## RESPONSE TO REQUEST FOR ADDITIONAL INFORMATION

### APR1400 Design Certification

Docket No. 52-046

RAI No.: 101-8007  
SRP Section: 09.05.05 – Emergency Diesel Engine Cooling Water System  
Application Section: 09.05.05  
Date of RAI Issue: 07/22/2015

Figure 9.5.5-1 Emergency Diesel Engine Cooling Water System Flow Diagram (Sheet 1 of 1)

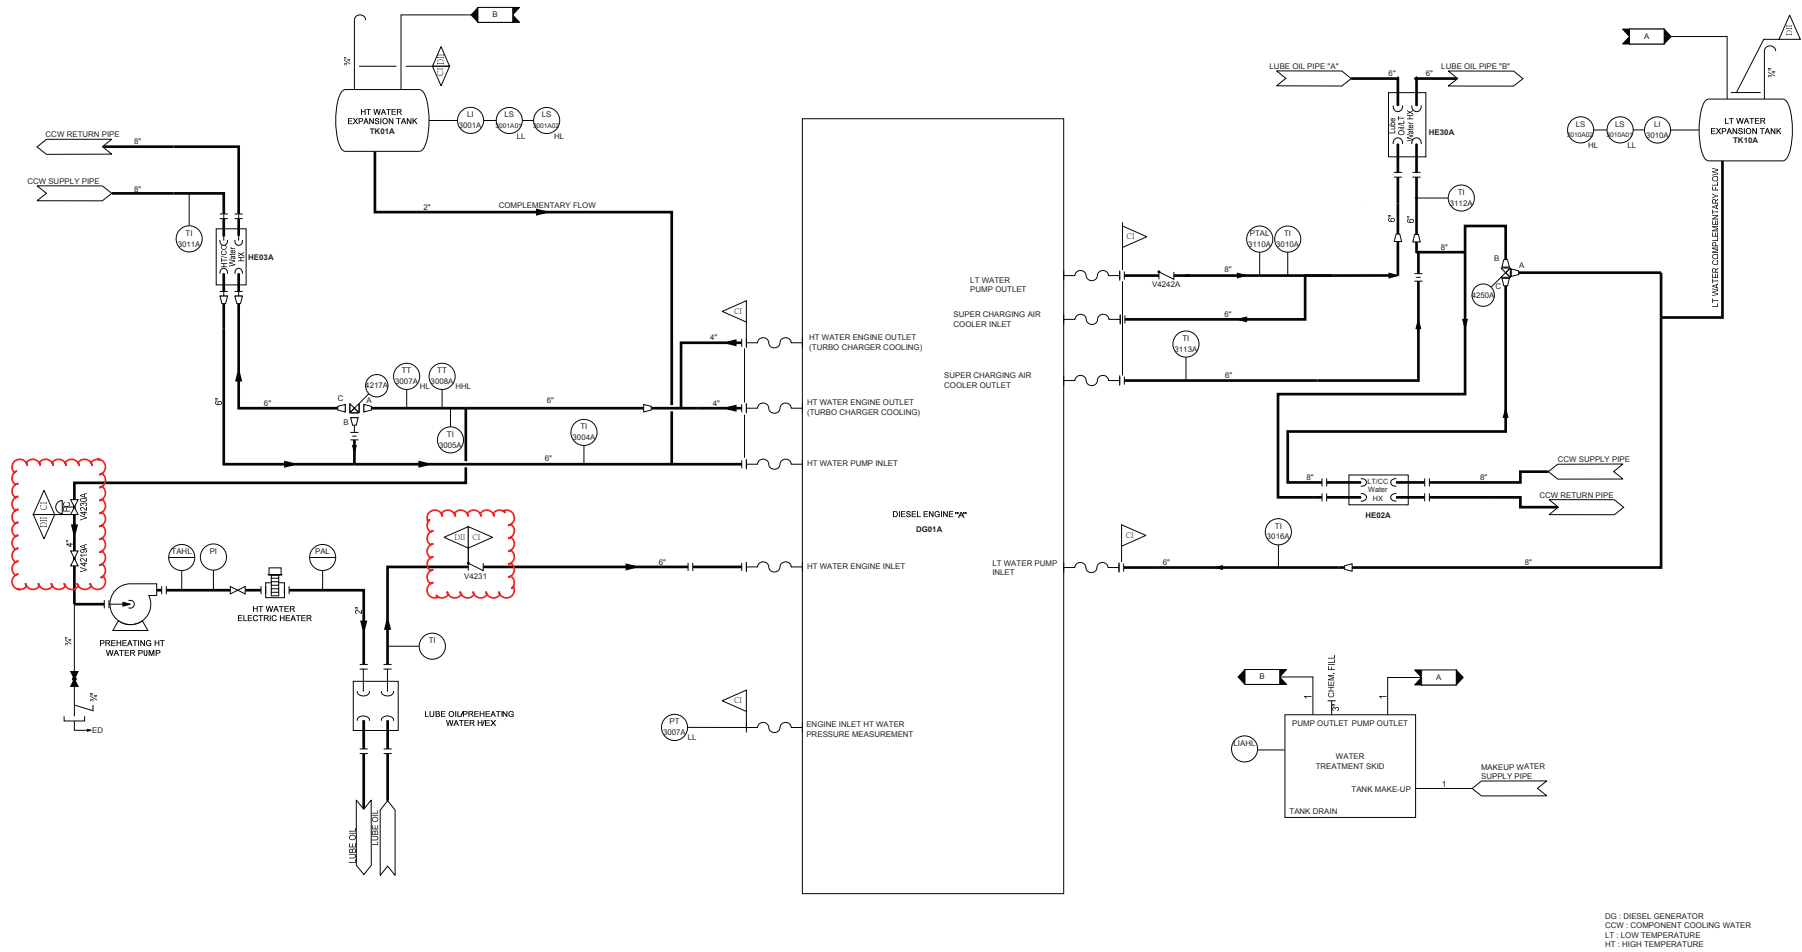
DCD Tier 2, Figure 9.5.5-1 contains the interface between the nonsafety-related pre-heat water system and the safety-related portions of the high temperature (HT) cooling water system. The figure shows an isolation valve classified as seismic category II and quality group D.

The applicant is requested to justify how this classification is sufficient to protect a safety-related, seismic category I system, in the event of failure of a nonsafety-related SSC.

DCD Tier 2, Figure 9.5.5-1 shows the use of a three-way thermostatic valve in two locations high temperature and low temperature (HT and LT) circuits. DCD Tier 2, Section 9.5.5.2.2 states that “[t]he three-way thermostat valve splits the cooling water flow so only as much water passes through the heat exchanger as needed to maintain the proper water outlet temperature. The remainder bypasses the heat exchanger and returns directly to the water pump so that the total water flowing through the pump and engine remains essentially constant regardless of the ambient temperature of engine loading.”

This description seems consistent with the HT valve operation, but the LT valve operation is not included in the DCD. DCD Tier 2, Section 9.5.5 lacks a clear description of these three-way thermostatic valves and their operation and function.

The applicant is requested to provide additional details on the system’s use of three-way thermostatic valves and update the DCD accordingly.

The isolation valve is designed and classified as seismic Category I and quality group C.

Affected material in DCD Tier 1 and Tier 2 will be revised.

DCD Tier 1, Table 2.6.2-2 and Tier 2, Figure 9.5.5-1 and Tables 3.9-4, 3.9-13, and 3.11-3 will be revised as indicated on the attached markup.
